UNITED STATES PATENT AND TRADEMARK OFFICE

APPLICATION NO.	FILING DATE	FIRST NAMED INVENTOR	ATTORNEY DOCKET NO.	CONFIRMATION NO.
10/699,450	10/31/2003	Venkata A. Bhagavatula	SP02-275	2835
22928	7590	06/15/2005	EXAMINER	
CORNING INCORPORATED			ROJAS, OMAR R	
SP-TI-3-1			ART UNIT	PAPER NUMBER
CORNING, NY 14831			2874

Office Action Summary	Application No. 10/699,450	Applicant(s) BHAGAVATULA ET AL.	
	Examiner Omar Rojas	Art Unit 2874

DETAILED ACTION

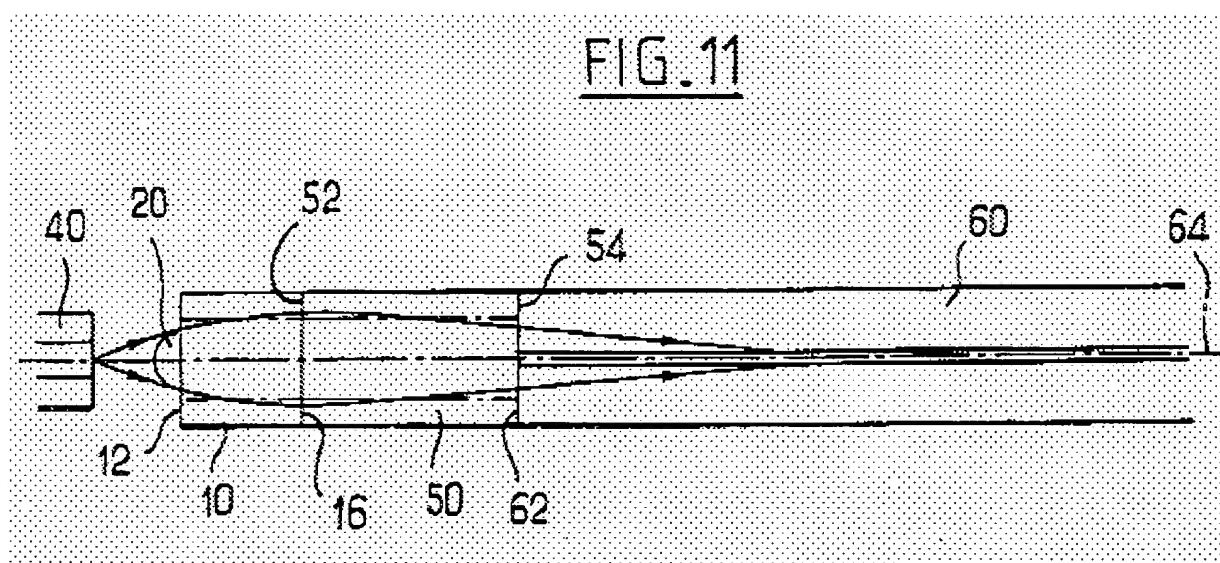
Regarding claim 1, Semo discloses a fiber lens (e.g., see Figure 11), comprising:

a graded-index lens 50; a single-mode fiber 60 disposed at a first end of the graded-index lens 50; and a refractive lens 20 having a hyperbolic shape disposed at or near a second end of the graded-index lens ("GRIN") 50 to focus a beam from the single-mode fiber to a diffraction-limited spot. Figure 11 of Semo is reproduced below.

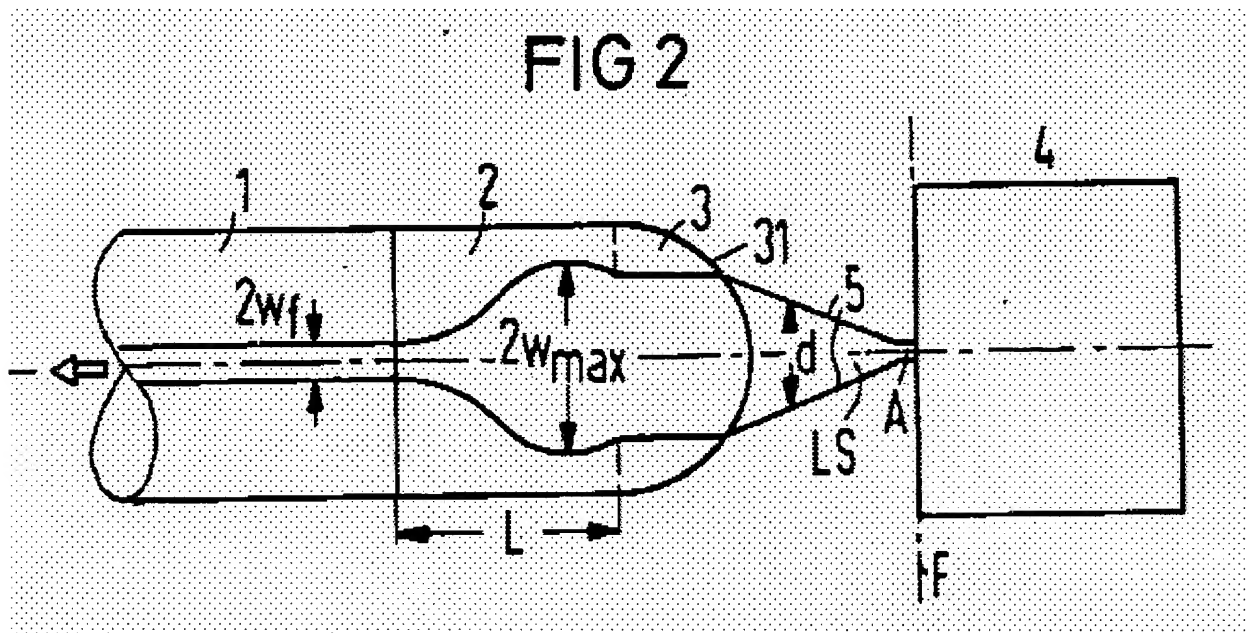
It is noted that the Siemens references is published in a foreign language. An International Search Report for corresponding PCT application no. PCT/US03/39641 (provided in an information disclosure statement) indicates that claims 1, 2, and 6-16 are anticipated by Siemens. The Search Report is taken as *prima facie* evidence that claims 1, 2, and 6-16 are anticipated by Siemens under 35 U.S.C. 102(b). As shown in Figure 2 of Siemens, reproduced below, a fiber

lens comprises: a graded-index lens 2; a single-mode fiber 1 disposed at a first end of the graded-index lens 2; and a refractive lens 3 having a hyperbolic shape disposed at a second end of the graded-index lens 2 to focus a beam from the single-mode fiber 1 to a diffraction-limited spot.
